<b>AMENDMENT OF SOLICITATION/MODIFICATION OF CONTRACT</b>				1. CONTRACT ID CODE <b>J</b>		PAGE OF PAGES <b>1   11</b>	
2. AMENDMENT/MODIFICATION NO. <b>0004</b>		3. EFFECTIVE DATE <b>04-Mar-2007</b>		4. REQUISITION/PURCHASE REQ. NO.		5. PROJECT NO.(If applicable)

6. ISSUED BY AFGHANISTAN ENGINEER DISTRICT US ARMY CORPS OF ENGINEERS KABUL APO AE 09356		CODE <b>W917PM</b>		7. ADMINISTERED BY (If other than item 6)  <b>See Item 6</b>		CODE

Questions and Answers Amendment 0004

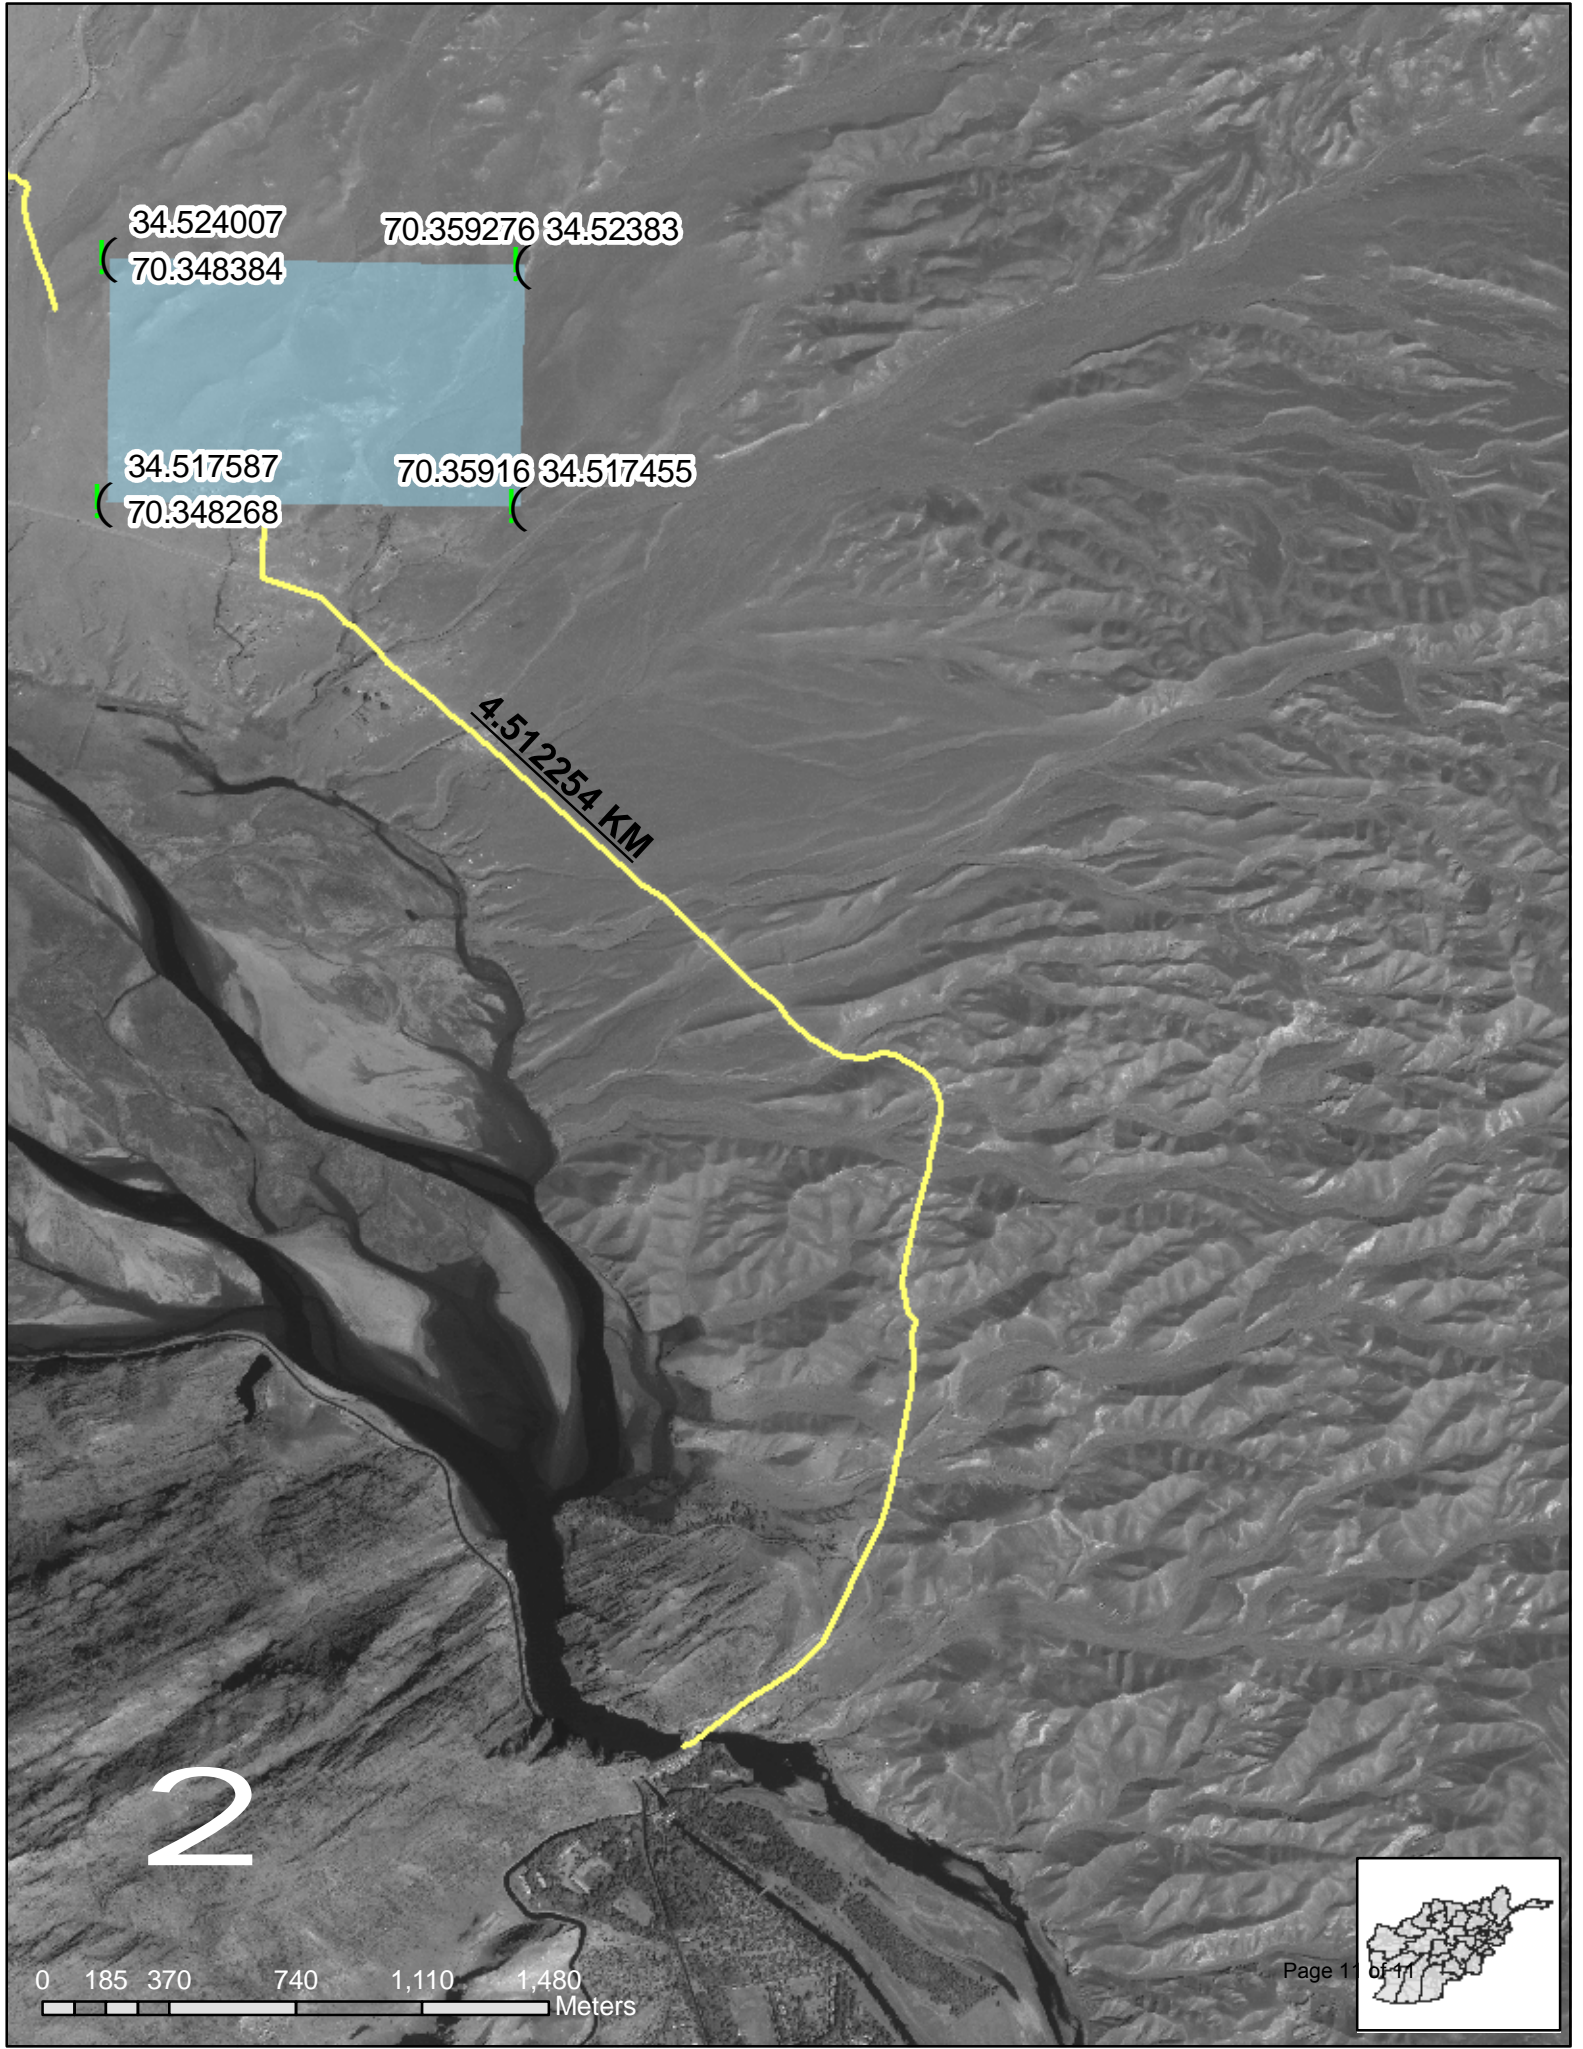
Q.53 ARE THERE ANY INHABITANTS AND BUILDINGS AT THE PROJECT SITE.

Q.54 PER RFP SECTION 01010 PARAGRAPH 1.1.2 IT IS STATED THAT “ALTITUDE: THE SITE HAS ROLLING HILLS. THE ELEVATION VARIES FROM APPROXIMATELY 621 (METERS) TO 650 (METERS). SEE APPENDICES FOR AERIAL OF SITE.

A.53 There are no inhabitants on the site but there are a few ruins that will have to be demolished.

A.54 The information came from several GPS position shots. All survey data will have to be gathered by the successful Contractor, then produce a correct Topographical Map of the sit for final Master Plan to meet RFP requirements.
